AUTOMATIC FIRE SUPPRESSION SYSTEM – TAMPER SEAL REPLACEMENT

Prevost vehicles

Special Bulletin

SP21-300

Figure 2

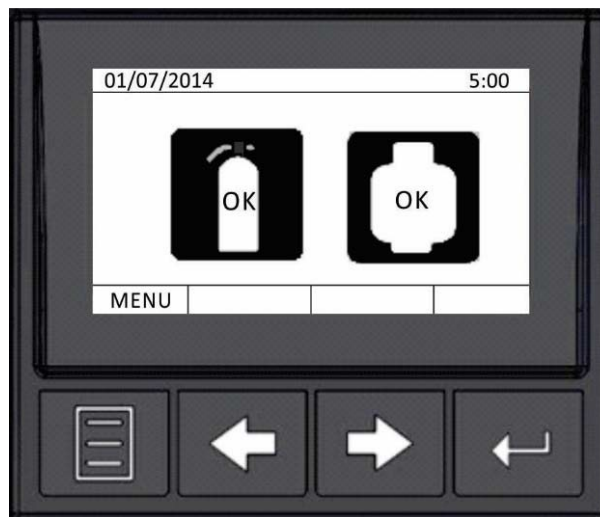
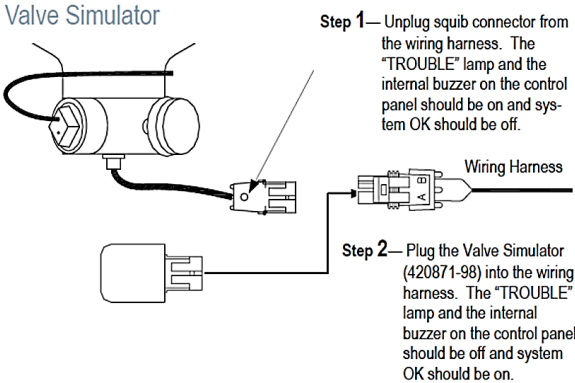
1. Confirm the system is operating in a normal "OK" state.

NOTE: Steps 2 through 4 are not required to perform this conversion but are recommended.

Figure 5

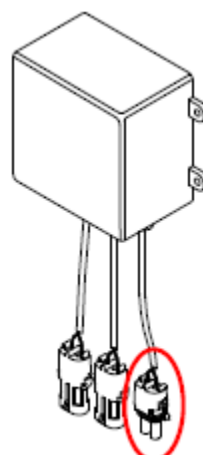
3. Remove power from the system by removing the fuse(s) or disconnecting the J3 connector of the battery backup module if one is present.
4. Confirm that the system's controller is indicating power has been removed.

Figure 9

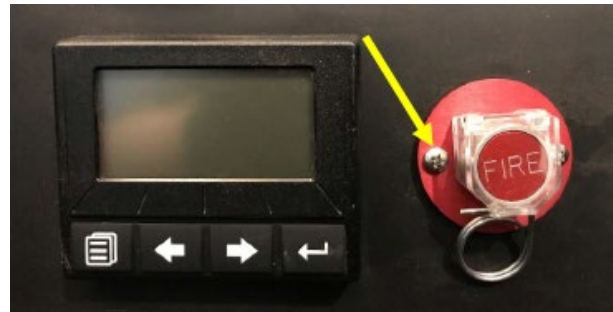
- After determining from which side the pin will be inserted and removed, remove the mounting hardware holding the manual discharge on the OPPOSITE side from which the pin will be pulled.

Figure 16

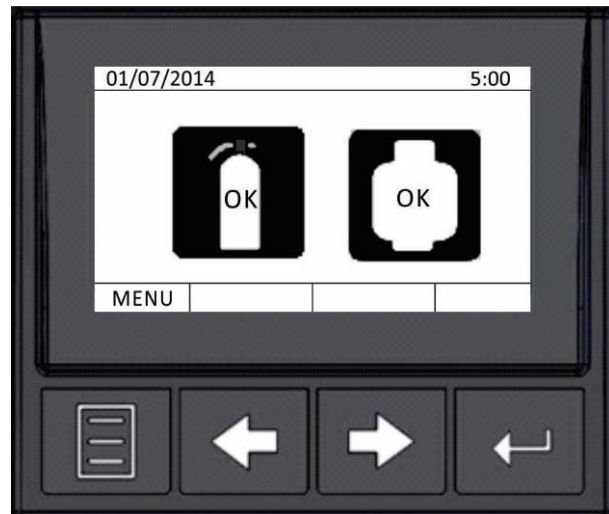
15. With the system in the OK state and no fire alarms activated, disconnect the Valve Simulator(s) and reconnect each extinguisher's firing mechanism connector to the wiring harness.

16. Reconfirm the system is in the "System OK" state.
